**RICHARD L. MEEHAN**

Re: Dairi Prima Minerals (DPM) Mine site risks and Tailings disposal safety. Review of Dairi April 2021 EIA Addendum.

Subsequently I have reviewed Dairi Prima Mineral's (DPM) newly revised Addendum Type A<sup>2</sup> to their Environmental Impact Assessment<sup>3</sup>, and present my findings on that addendum. I do this in summary form and have also made a video version<sup>4</sup>.

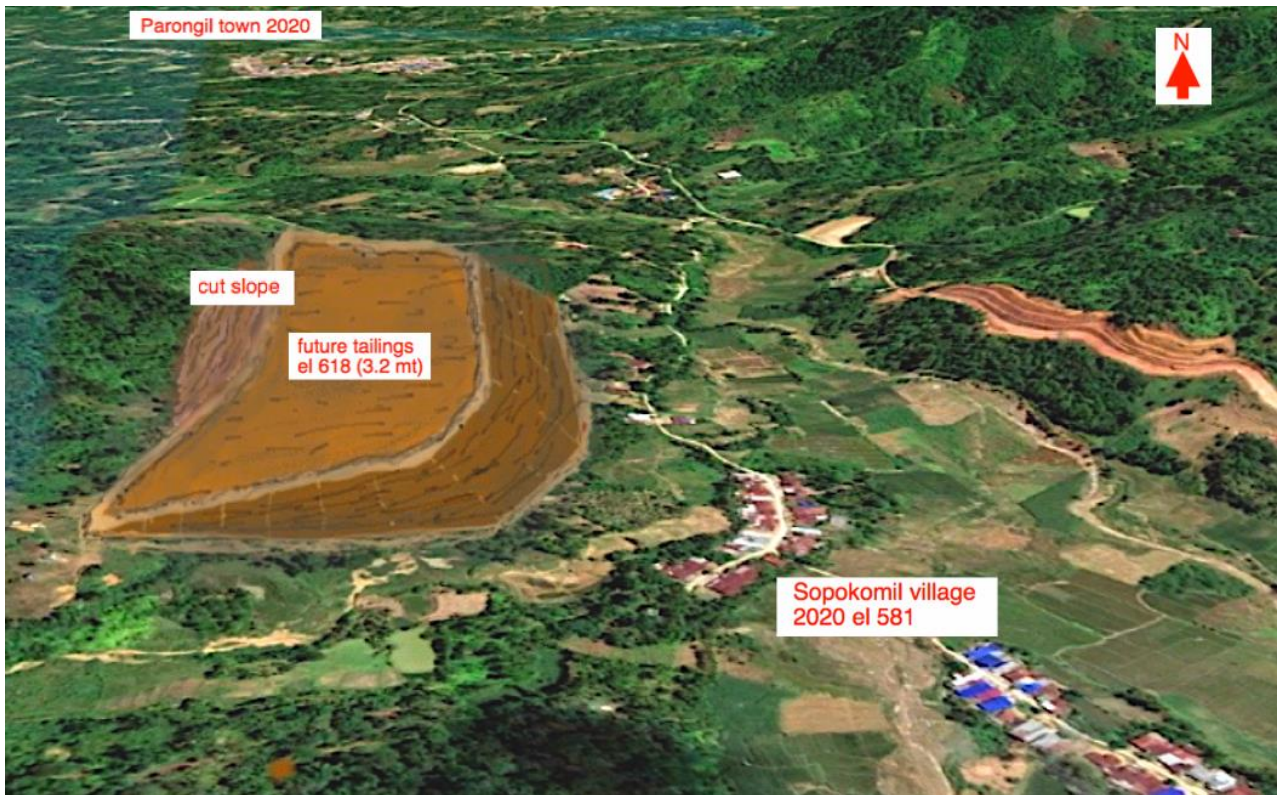
The new EIA2021 Addendum appears to request approval for a 1.2 million tons tailings storage facility, but I understand from various plans 2005-2019 that there is a long-term plan to expand the mine so that the eventual TSF would be to 3.2 million tons. I have used the latter dam size as my working assumption in my sketch figure 1 following. However even if the TSF is ultimately limited to the 1.2 mt size, the hazards to local communities would still exist.

*Figure 1. Planned configuration of TSF, 3.2 million tons at elevation 618. TSF configuration (brown color) from EIA Addendum fig 2.22 sketched onto Google Earth image by the author. Breach of the tailings dam above the Sopokomil village is likely in a strong earthquake because the ground between and beneath the village and the TSF and the dam foundation is unstable volcanic ash soils subject to liquefaction and landsliding.*

Figure 5 Cross section as verified EIA2021 with likely ground failure scenario brought on by rain and earthquake

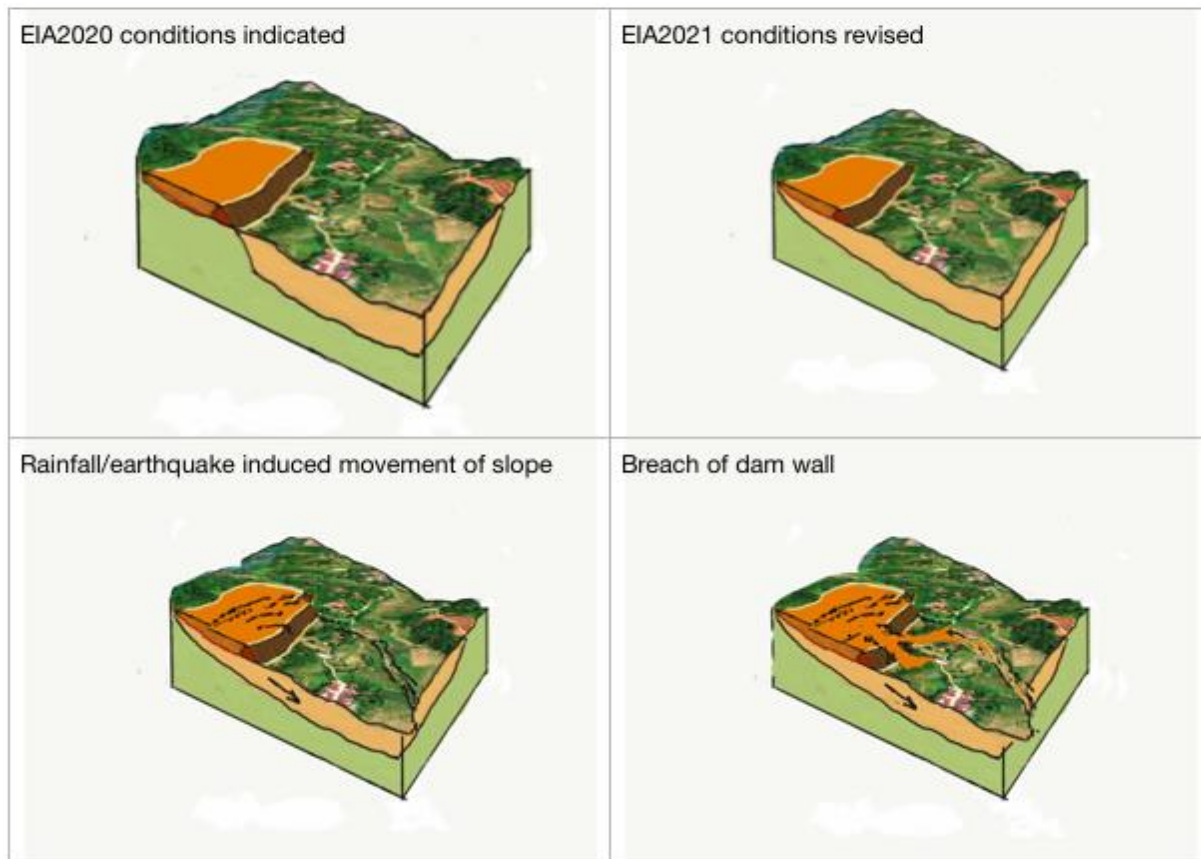
The scenario I have in mind is illustrated on the sequence of images on figure 3 and figure 4. Basically, the whole slope on which the TSF is located could move downslope under the weight of the TSF (indeed, Toba tuff has seen similar landslides (see Appendix A) even without loading associated with a TSF). The lower bound of sliding may be within in the Toba tuff layer or at zones of weakness and high pore pressure at the base of the tuff. With such a movement it is difficult to believe that the proposed TSF would not fail, either collapse or by rupture of linings.

Figure 10 Standard penetration tests in Toba tuff at Sarulla geothermal plant.

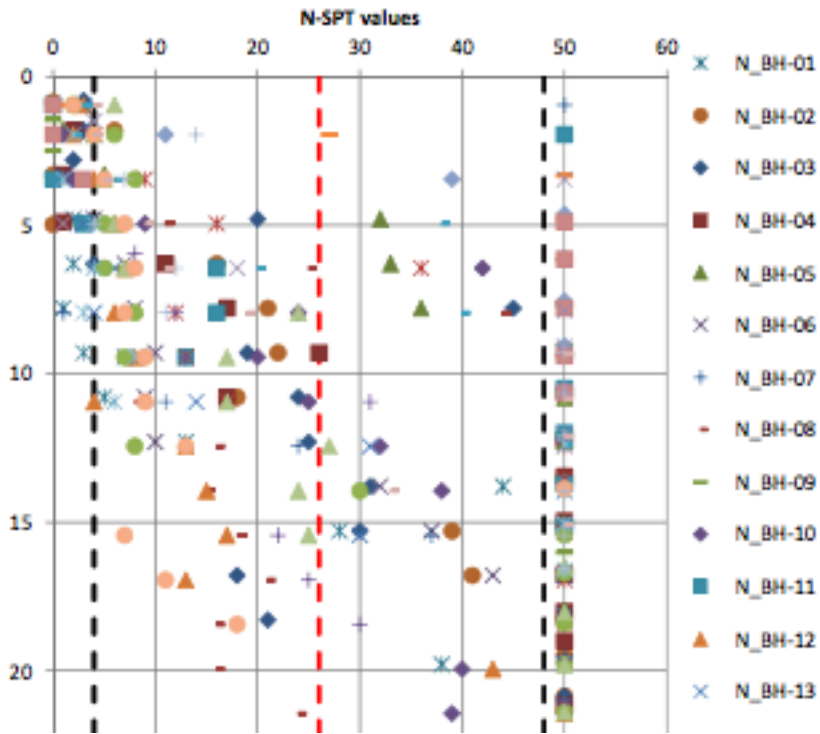
A proposed geothermal plant, the Sarulla project also in the Toba tuff involved recent site explorations which are documented as showing unwelded Toba tuff as being in a loose condition (Standard penetration test N values less than 10) with potential earthquake liquefaction potential in the upper 10-30 meters.

*Figure 13 EIA2021 shows landslide potential adjoining TSF*

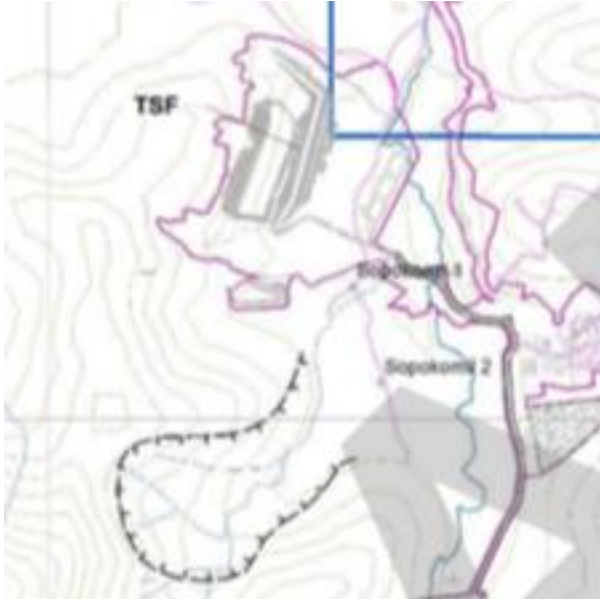
Heavy rains in December 2018 also caused slope instability in the area of DPMs proposed TSF. These are clearly visible on Google Earth and known to the local people for the heavy flow of rock debris that filled local streams. It is described in the latest EIA2021 which also includes a map of the valley adjoining the village of Sopokomil which is indicated as being susceptible to such slides. Many of the most visible slides on upper slopes seen on say Google Earth are debris flows originating in older rock, not Toba tuff, but it also seems likely that sliding in Toba tuff was involved and this is stated as a fact in the EIA2021:

The landslides are attributed to the presence of the Toba tuff and although the EIA does not show landsliding at the TSF site itself there is reason to believe that the area is also unstable even without the presence of a TSF. The added weight of the TSF whether of short term or long term size, would aggravate the existing instability.
